**BEFORE THE NORTH CAROLINA UTILITIES COMMISSION
DOCKET NO. E-100, SUB 179**

In the Matter of:)	JOINT COMMENTS OF THE
Duke Energy Progress, LLC, and)	NORTH CAROLINA
Duke Energy Carolinas, LLC, 2022)	SUSTAINABLE ENERGY
Biennial Integrated Resource Plans)	ASSOCIATION, SOUTHERN
and Carbon Plan)	ALLIANCE FOR CLEAN
)	ENERGY, SIERRA CLUB, AND
)	NATURAL RESOURCES
)	DEFENSE COUNCIL

Figure 1: Annual NEM Installations in DEC⁵⁶

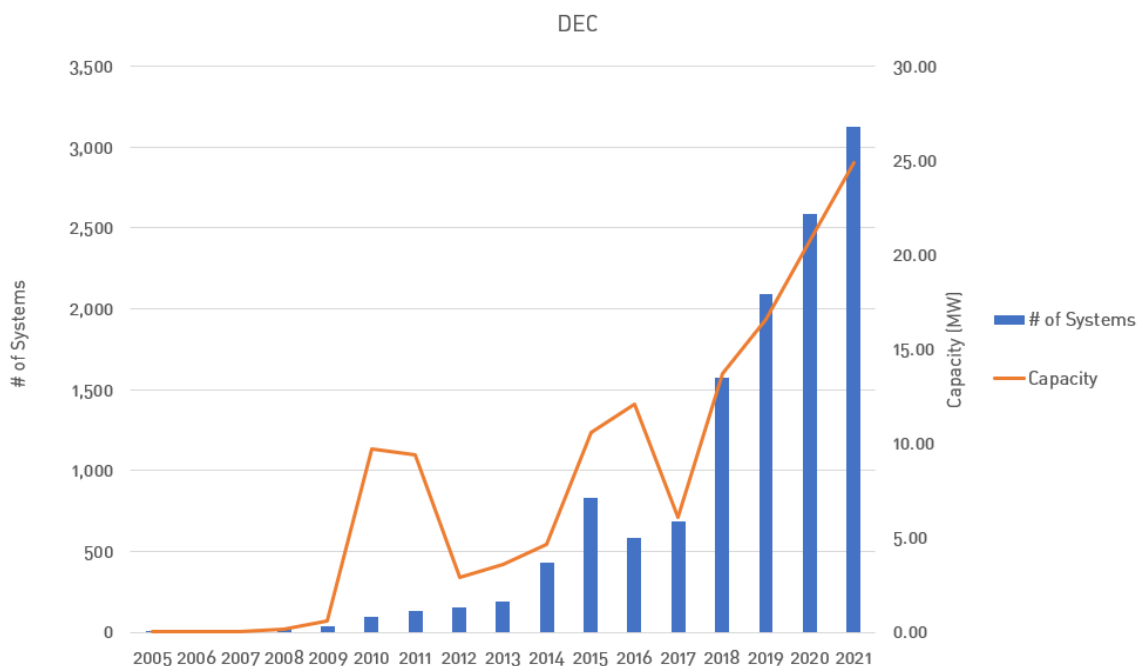
Duke Energy’s projections for future net metering (NEM) adoption are too conservative. The projections for both North and South Carolina included in Appendix G show an additional 2,027 NEM customers for DEC per year and an additional 850 NEM customers for DEP per year from 2022 to 2030. These numbers are below recent trends. There were more than 3,000 new NEM customers for DEC and DEP each in North Carolina 2021.

Considering recent trends, the possibility of projected rate increases, and the potential of a new NEM incentive,⁵⁷ it is not reasonable to expect residential solar adoption rates to decline over the intermediate Carbon Plan planning horizon. The Commission will also have an important role to play in providing a supportive framework for customer adoption of rooftop solar, which allows for private investments in renewable energy that further carbon reduction requirements.

10. Adopt more reasonable assumptions for customer adoption of NEM for carbon planning purposes and continue to offer reasonable support for private investments in distributed renewable energy resources.
